CHANGE ORDER

PROJECT:	Washoe County – Nevada Shared Radio System	CHANGE ORDER NO.:	8
		DATE:	09/22/2020
SELLER:	Harris Corporation Communication Systems Segment	CONTRACT DATE:	September 27, 2018
SELLER ADDRESS:	221 Jefferson Ridge Parkway Lynchburg, VA 24501

Change Order No. 8 Detailed Description

Figure 23: Overall Microwave Topology

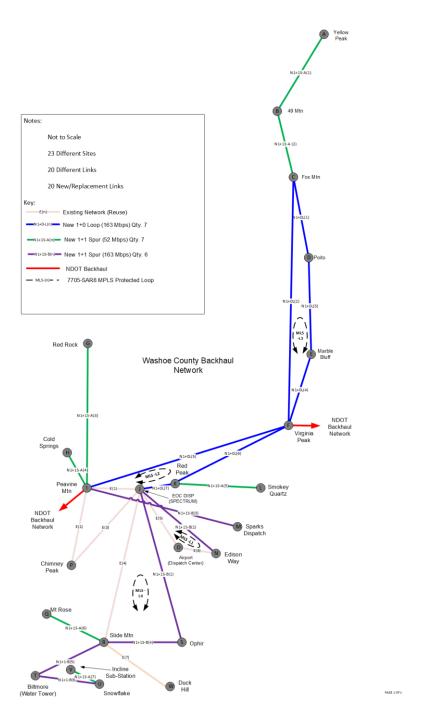
Harris will design and implement the new Washoe County microwave network that will provide high-speed wireless Ethernet transmission via the Nokia 7705 SAR-8 MPLS router installed at each Washoe County site. The new Washoe County microwave network will interconnect with the NDOT microwave network to form the NSRS backhaul. Harris will perform all services to implement all new equipment that includes microwave dishes, waveguide, radios, dehydrators, Network Management System and MPLS routers to provide network connectivity between the RF sites, cores, and existing PSAPs in Washoe County. Harris has reviewed the existing Comsearch Microwave Path Data Sheet provided by Washoe County and have used this data along with the selected RF sites in Washoe County to provide a microwave backhaul network solution that will interconnect to the NDOT microwave network which forms the NSRS. The new Washoe County microwave network solution comprises of 20 links which is a combination of loop-protected microwave links and monitor hot standby (MHSB) links. These links will interconnect the cores, RF sites and PSAPs to the NSRS. Each link will be designed with a path availability of 99.999% based on the receive threshold to provide the required link bandwidth.

The new Washoe County microwave network will include the Nokia 7705 SAR-8 MPLS routers for routing all packets between microwave sites, core locations and between NDOT and Washoe County microwave networks. In the event of a microwave path failure within a microwave loop, the 7705 SAR-8 will automatically reroute traffic to the opposite direction of the network. For RF sites that are connected by microwave spurs, a 1+1 MHSB radio will be installed to increase the reliability of the link. Harris has designed the microwave network based on the topology provided in Figure 23 below. The main microwave loop for interconnecting the two core sites in Washoe County consists of a 163 Mbps 1+1MHSB link with 7705 SAR08 MPLS backup loop protection using available bandwidth of existing links. The two cores are located at the EOC Dispatch and Edison Way locations. The northern loop and all spur sites will have links that support 52 Mbps radios. The Washoe County microwave network will interconnect with the NDOT microwave solution which share network nodes at Peavine Mtn and Virginia Peak site locations. Harris will coordinate with NDOT to support the routing of packets between the cores, RF sites and PSAPs located on the Washoe County side and the NDOT side of the NSRS.

The existing microwave links in Washoe County were considered and are based mainly on Nokia (formerly Alcatel) DS1 microwave circuits. Analysis of the existing microwave paths that will be reused are limited in bandwidth due to the nature of the existing DS1 signaling and will need to be replaced with all new Ethernet based radios to meet the NSRS bandwidth requirements. The existing DS1 links will remain operational until full cutover to the new NSRS. At that point, the equipment for ten existing links that are being replaced will be removed only.
